# DOWNTOWN DESIGN REVIEW BOARD

RECOMMENDATION BOOKLET

# 600 WALL STREET

SEATTLE, WASHINGTON | DPD# 3015251 | JANUARY 06, 2015

39 Floors Residential  
@ 9'-7" Floor to Floor

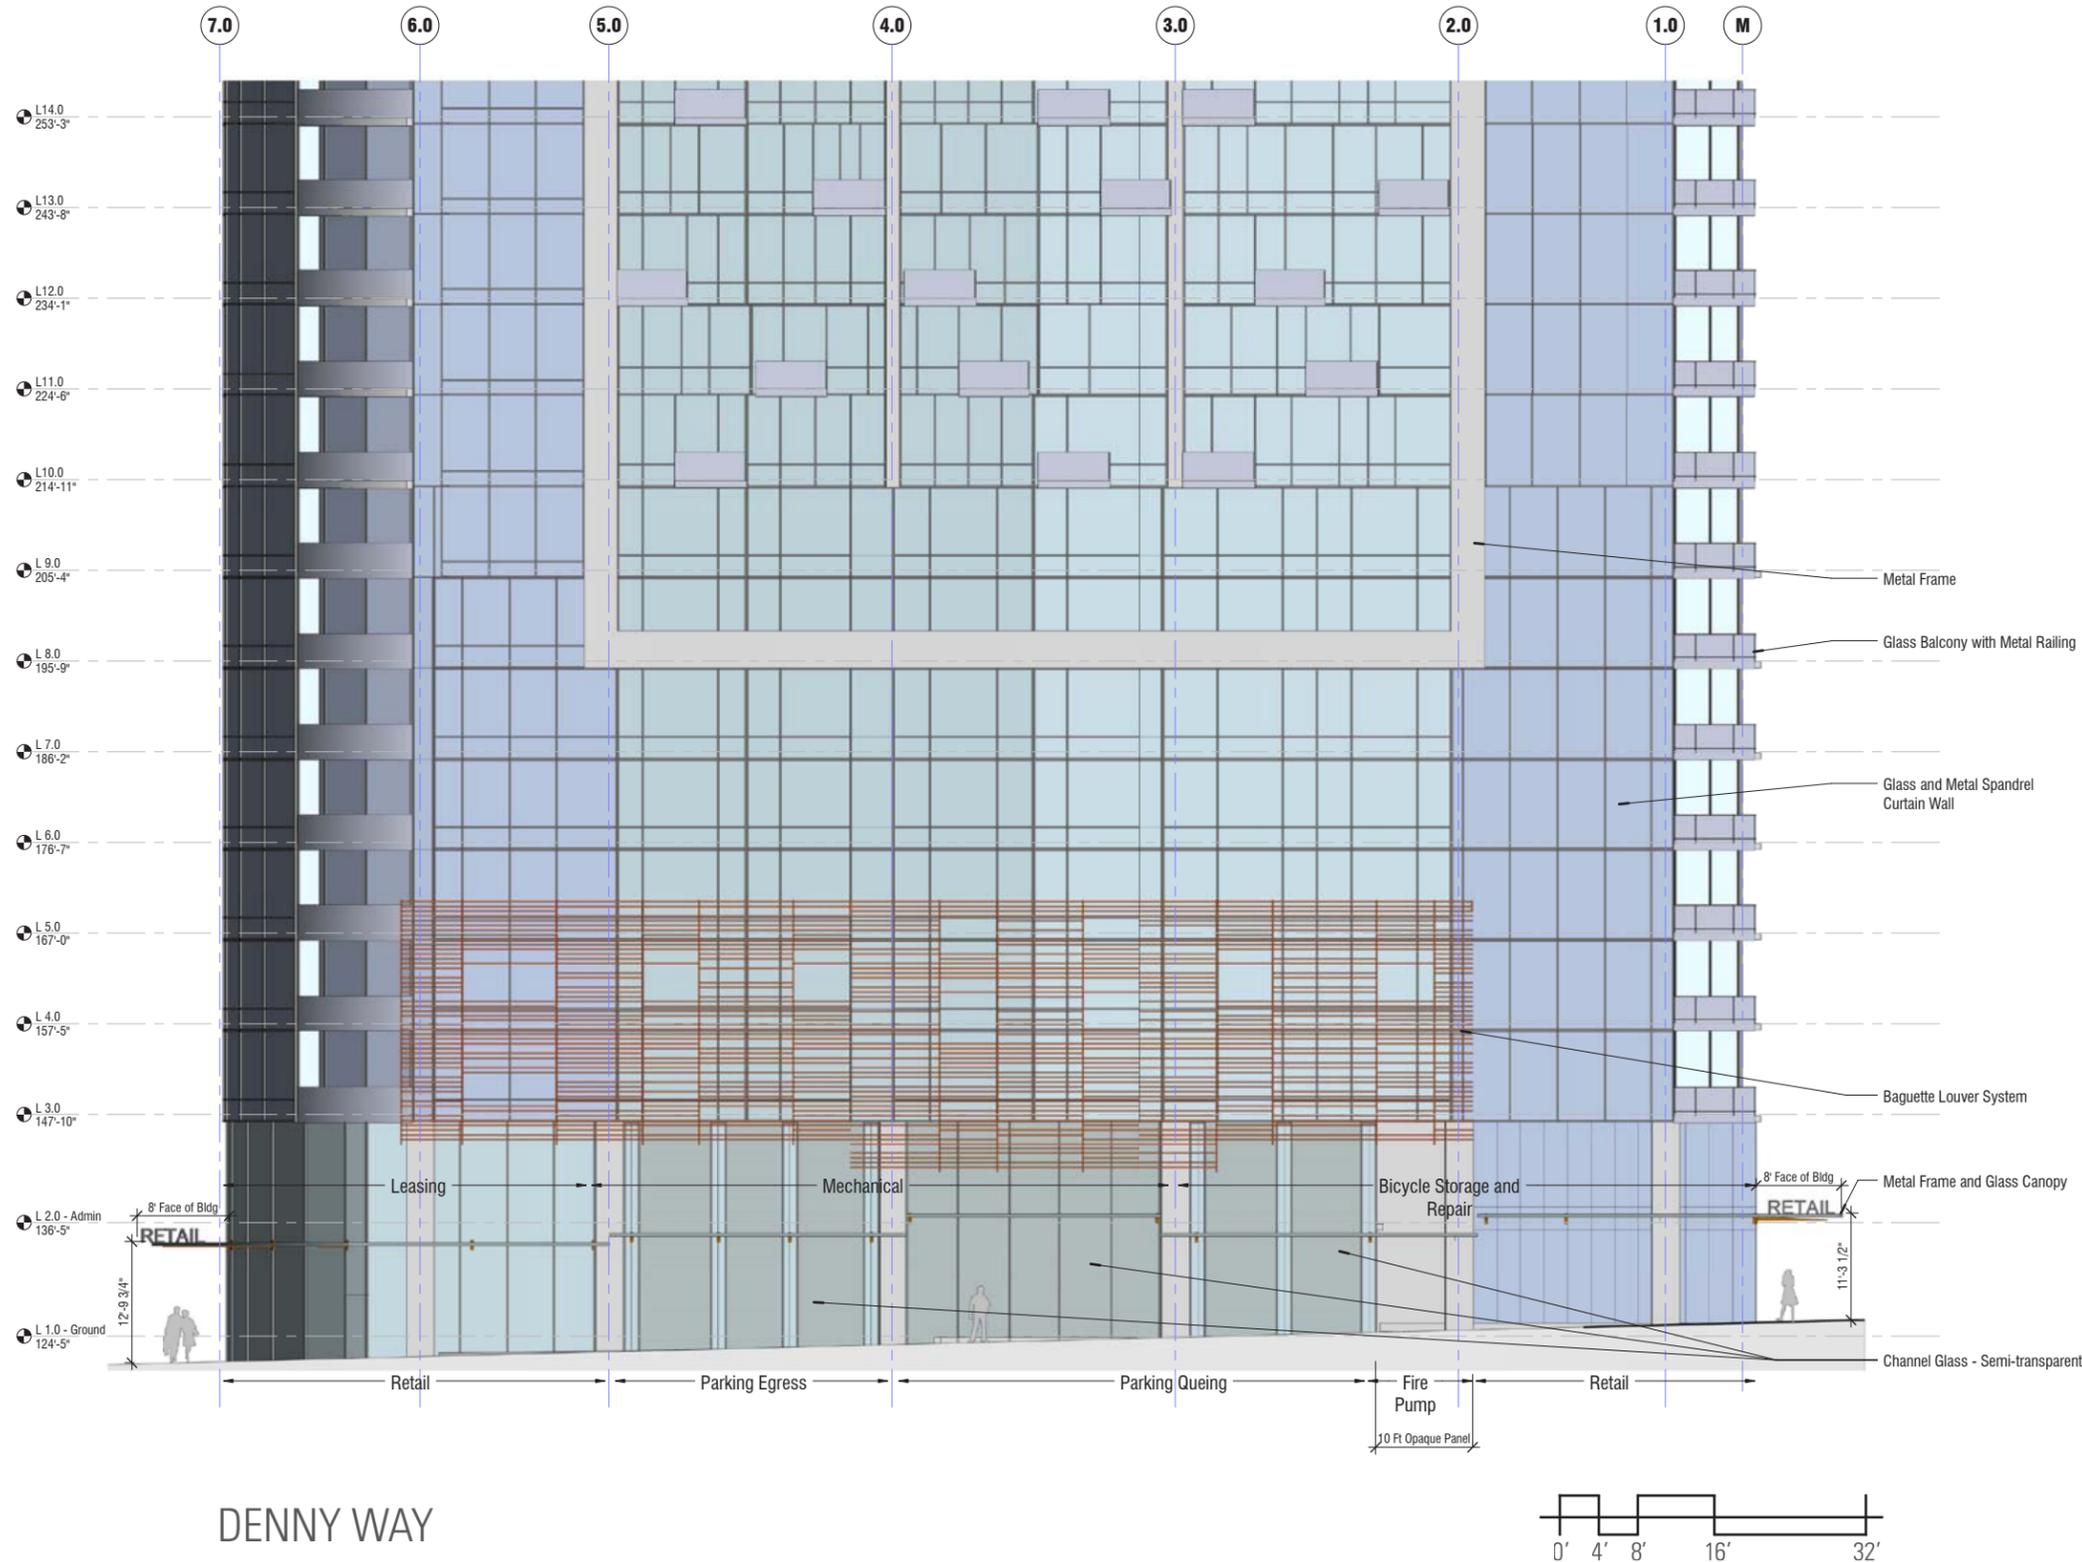
At the Early Design Guidance Meeting #2, the Board understood the below-grade excavation constraints and agreed the podium uses are much improved, in particular the amenity spaces on Denny. The Board supports the car share spaces on P-1. They discussed how the podium issues described in B-2 must transition well into the middle of the tower. To better evaluate this, the Board requires:

- Full page elevations with complete color and material notes.
- Large scale sections of the first 7-8 floors, showing dimensions and all façade elements (the ones shown on pages 36/37 are too small; ¼ inch scale preferred). NOTE: these should be composited with the landscape-only sections shown on pages 32-34.
- Large scale partial elevations (floors 7-8) adjacent to corresponding sections, which show all materials and light tone shadows, but not street trees.

The Board agreed the four white frames on the mid-tower provide middle scale to the three elevations, but they appear to be thin planes; show more details that establish the materiality and depth of these elements (as suggested by the white wall returns on pages 45,47 and 49), and show these accurately on floor plans. Also, explore the following as part of the elevation refinements:

- Explore a 2-3 floor transition between the podium and middle tower, starting the white frames at floorline 9 or 10 rather than 8.
- Explore the white frames along Denny starting above the podium, and not overlapping with the podium amenity expression, as currently shown on page 51.
- Explore reducing the width of the white frame elements, and/or their identical material/color nature on all three street frontages.
- To test these relationships, provide perspective studies like on pages 45,47,49, but that extend further upward into the tower.

- The frame has been redesigned to start at level 7, providing a 3 level transition between the podium and middle tower.
- The frame as previously applied is located in front of continuous building planes. To add more thickness to the frames would require reducing floor areas significantly. Instead, they have been redesigned to define the change in plane where the areas inset in the frames are deeper, varying from 1 foot at 6th and Denny streets and 2 feet at Wall.
- The metal panels at the inside of the frame continue at balconies that are adjacent to the frame providing more depth and variation.

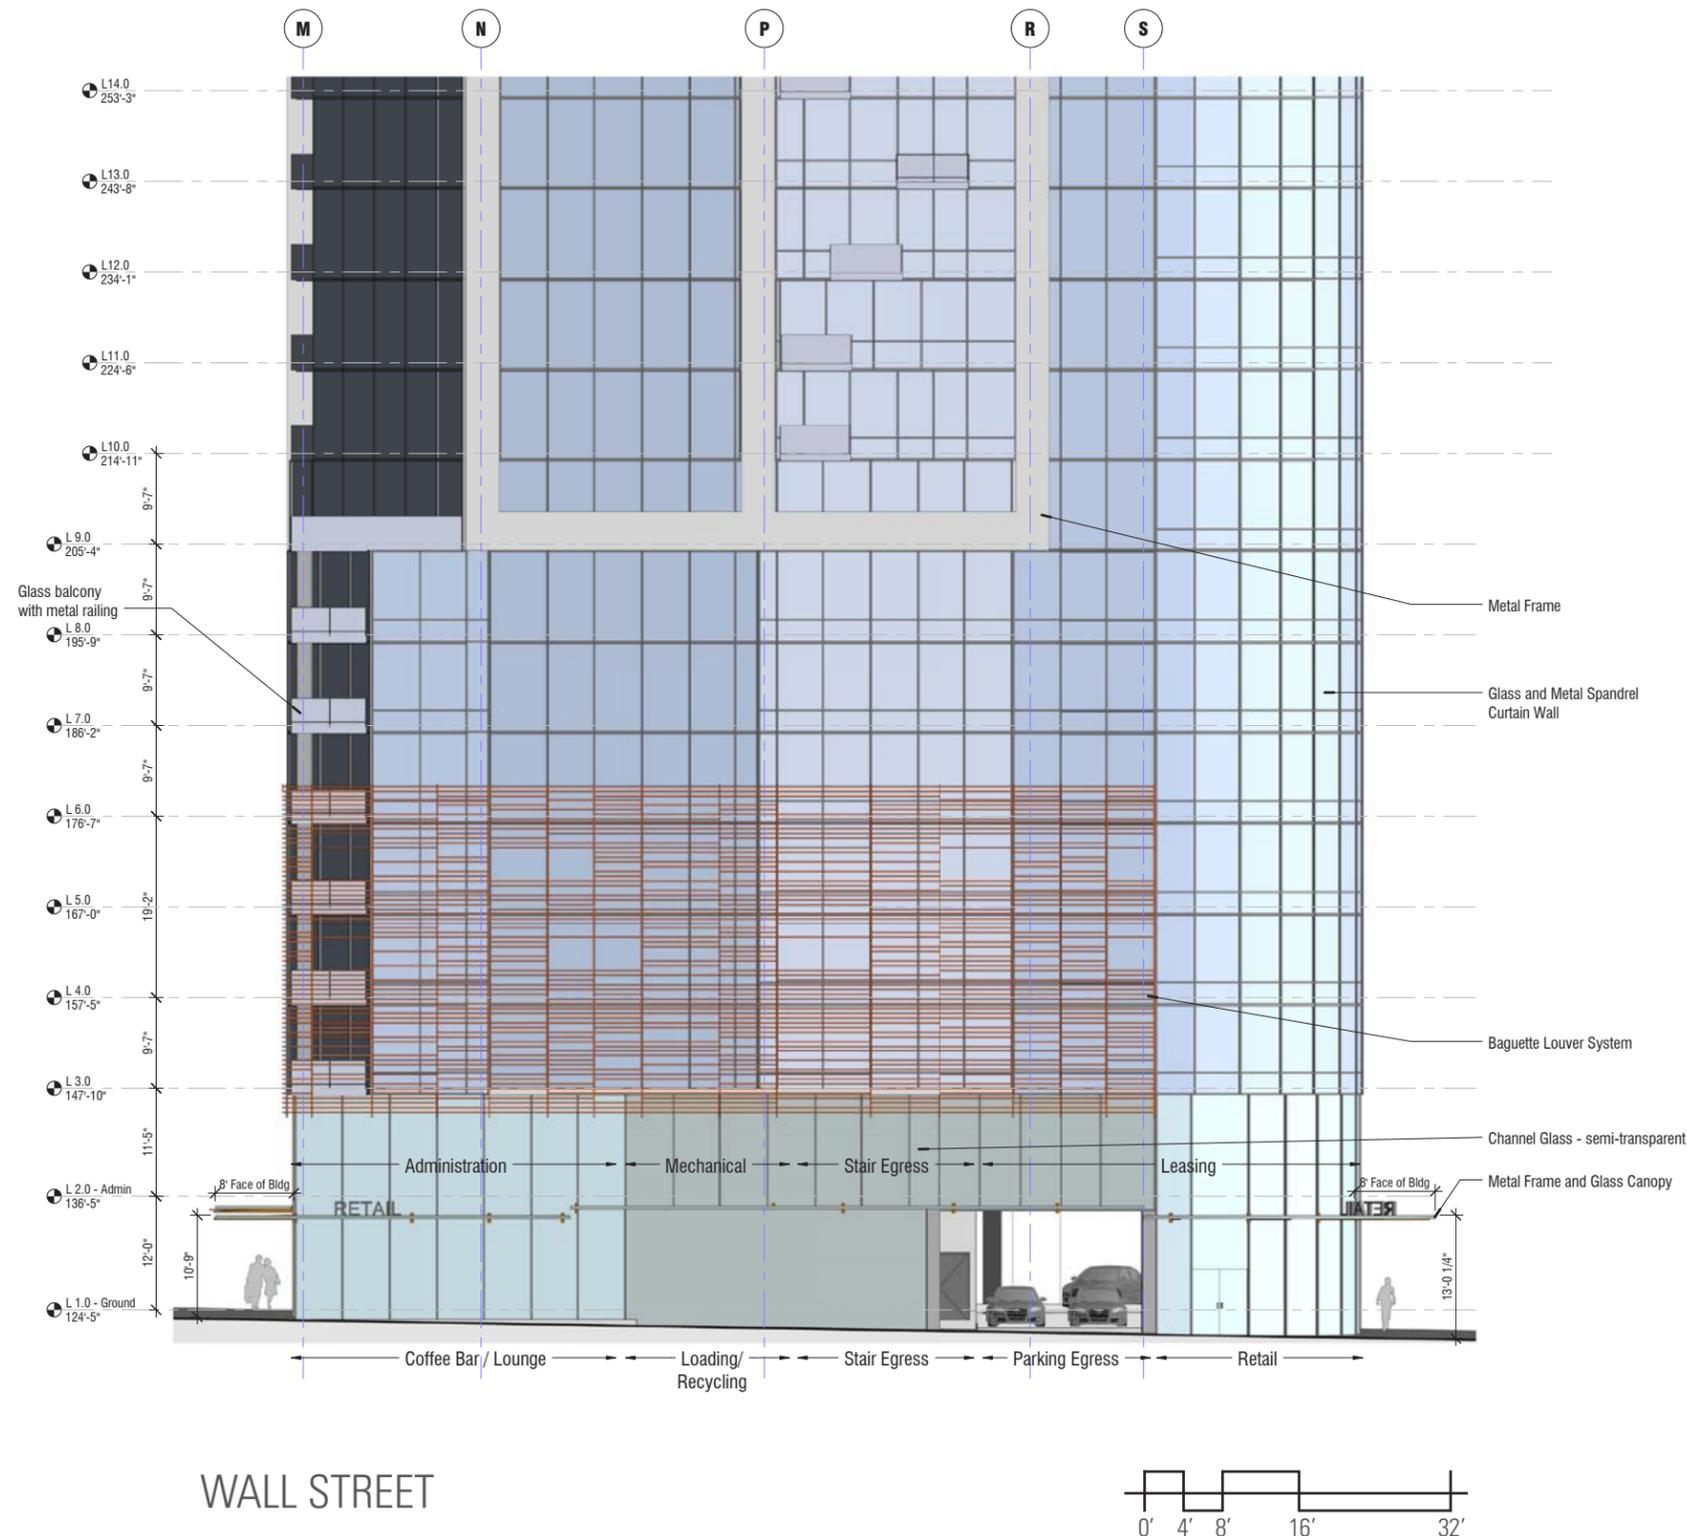
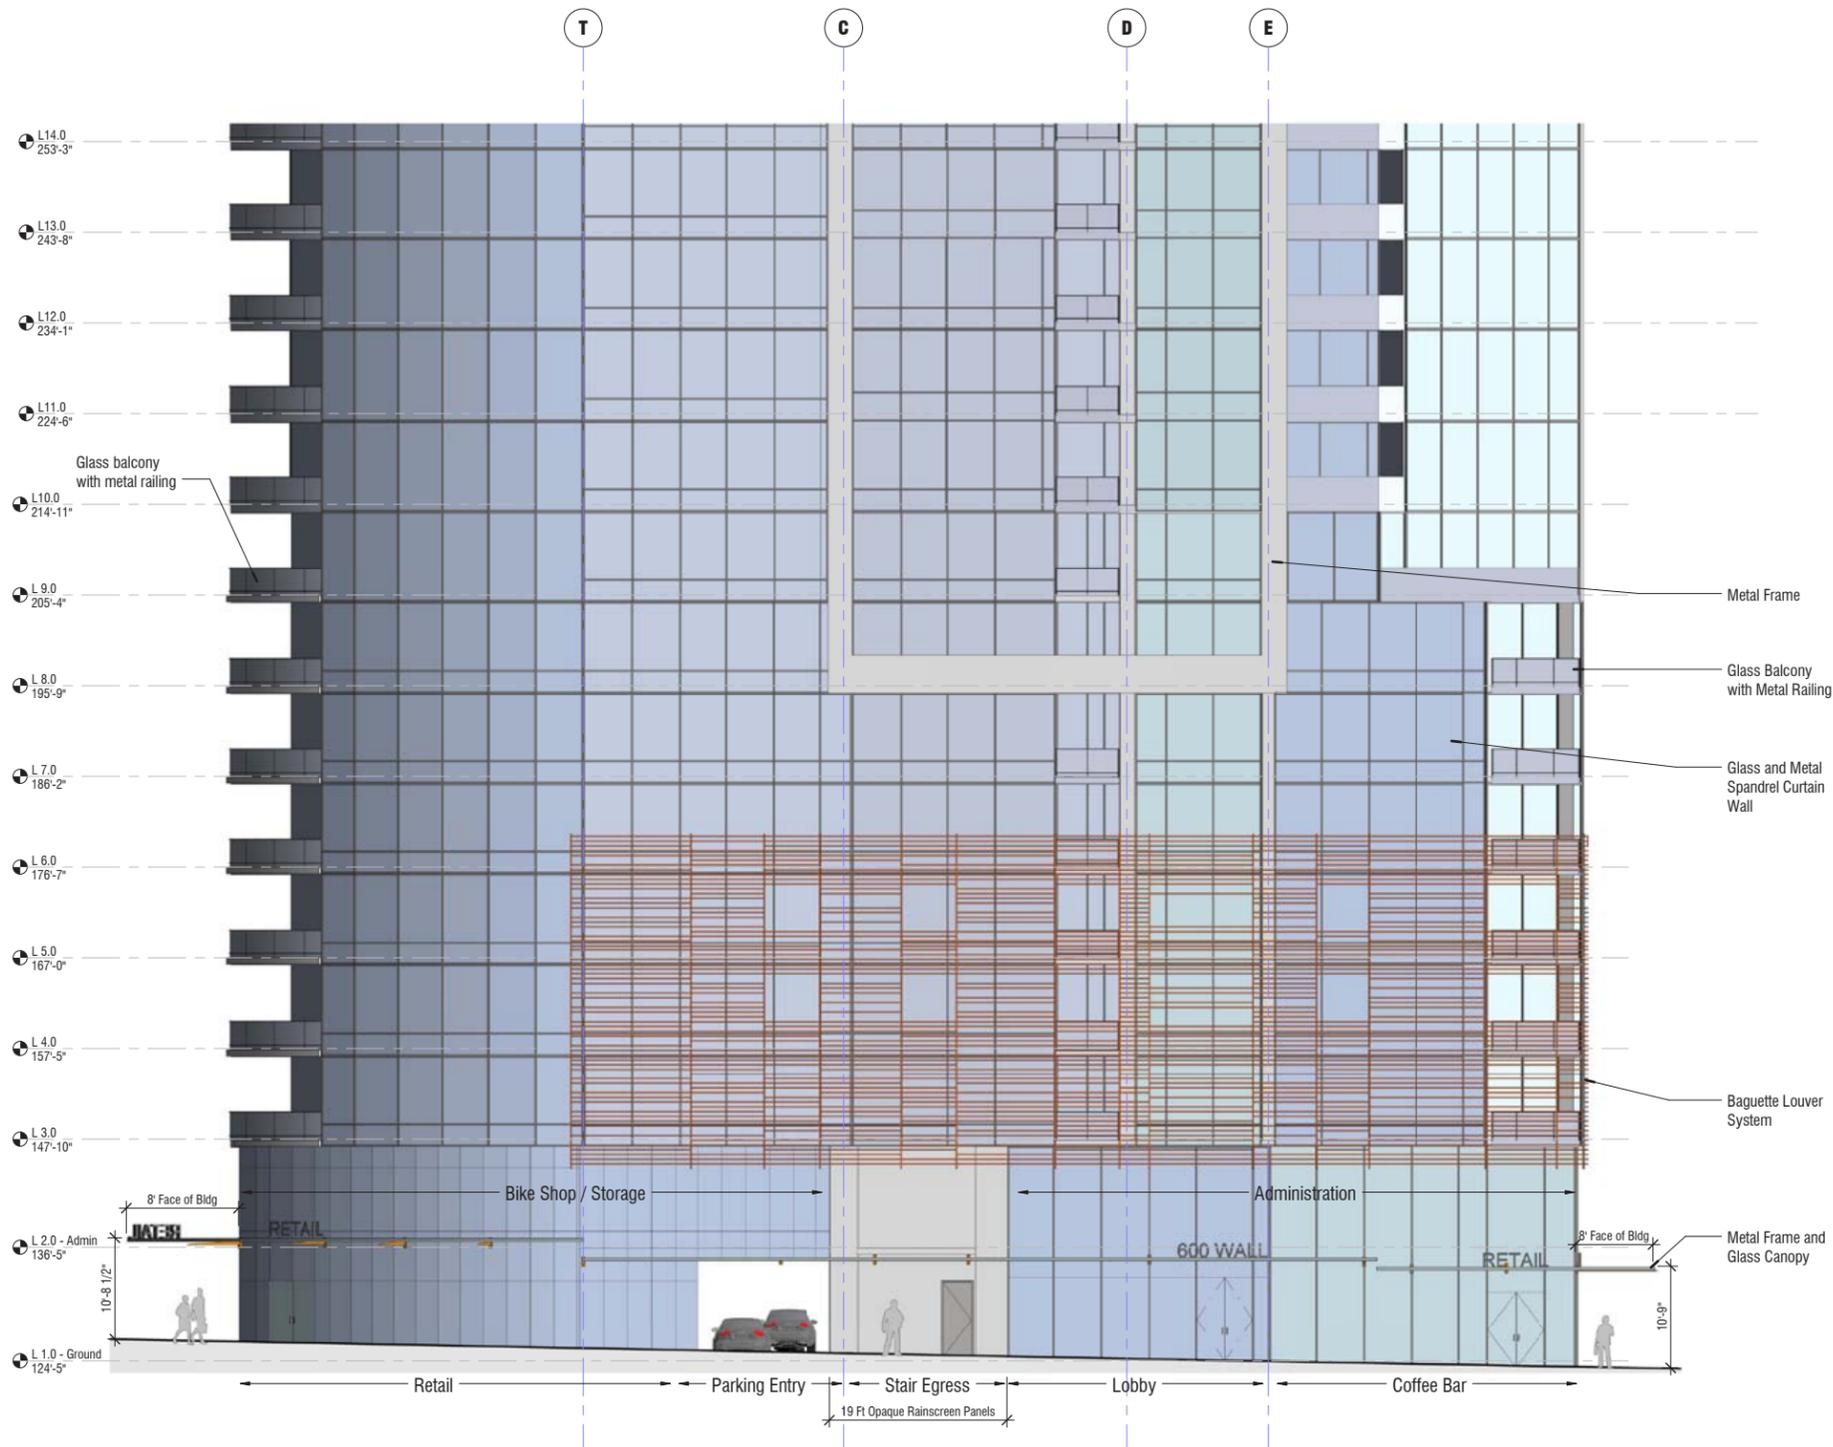
At the Early Design Guidance Meeting #2, the Board discussed how the proposal now includes a desirable podium scale, but that it appears grafted onto the tower or is too heavily expressed, especially at the 6th & Wall corner. The Board advised the following:

- Express the level 2-6 zone as a distinct corner form, but explore a 'more honest' material expression of the uses within. The red wall surfaces are too large and distracting.
- Explore channel glass or a similarly solid translucent treatment to clad the parking levels, with the floor slabs internalized and showcasing the vehicle lifts with transparent glass. Seeing shadows of the stored cars and frames is acceptable.
- Express the entire 24 ft high space of the amenity along Denny, rather than the partial red box; it should be distinct from the revised 6th/Wall corner treatment, and still accentuate the acute corners as different uses and different composition.
- Explore actual rental units, stacked in the 2 acute corners, rather than amenity/ studio spaces; units provide consistent and real activation, especially if balconies are included. (Also see comments under Departure #2)

At the Early Design Guidance Meeting #2, the Board discussed how the service areas appeared to be minimized at the perimeter, but requested more detailed information on the large scale elevations. The materials of the loading door, transformer, pump room and exits should provide transparency/translucency and pedestrian interest.

- Levels 2-6 have been redesigned to move the parking below the street. Level 2 uses now include bike storage, administrative offices, leasing residential uses, exit stairs, and mechanical.
- In addition to the louvers spaced to reflect the uses, varying levels of glazing transparency will be used to provide privacy in residential spaces and limit visibility into mechanical areas. The vehicle lift will be showcased as originally proposed.

- All service areas will be semi transparent or translucent and accented with art and lighting.
- Loading and recycling access will be at the vehicle exit opening.
